DOOLEY'S LIDCOMBE CATHOLIC CLUB - SSD 7603

COMMENTS FROM CUMBERLAND COUNCIL

Thank you for the opportunity to comment on the Concept Proposal for Tourist Related Purposes and Detailed Proposal for early works at Dooleys Lidcombe Catholic Club, Lidcombe, SSD 7603.

Figure 1. Site area (outlined in yellow) recommended to re-estimate the FSR.

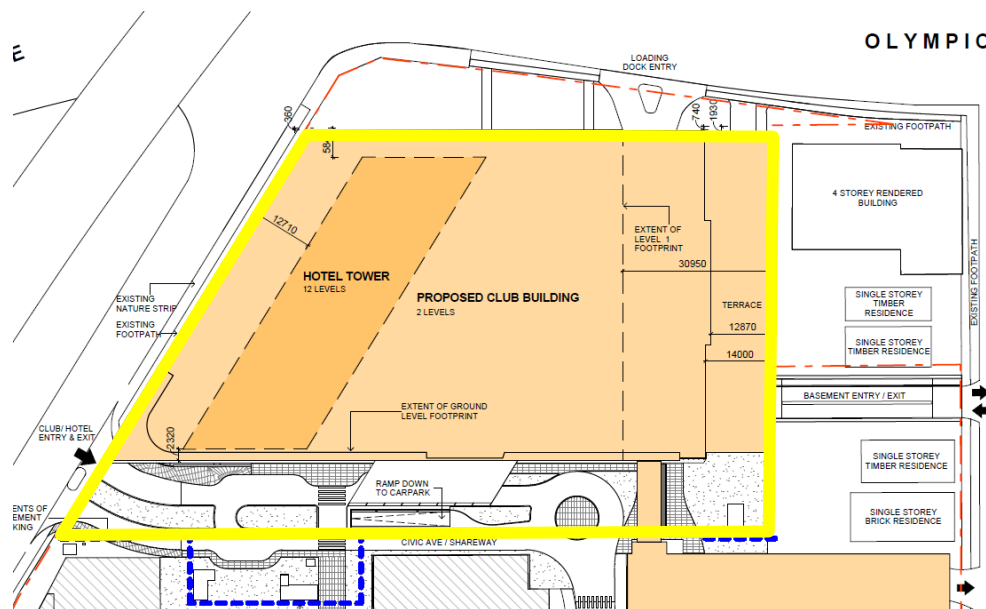
- h. The stated FSR of 1.23:1 is inaccurate as shown in tables 2 and 3 below, as 10 of the hotel levels are calculated as if they are only one level.

The 'site area' calculations include the existing club site, which is not part of the first stage of the development. Therefore, the potential FSR can be substantially higher following the completion of both phases of development. A re-estimate of the site area for the club/hotel complex based on more appropriate site boundaries (as outlined in yellow on Figure 1 below) would be approximately 9,960m².

The resulting FSR would be approximately 2.73:1 (ie 27,178m² / 9,960m²).
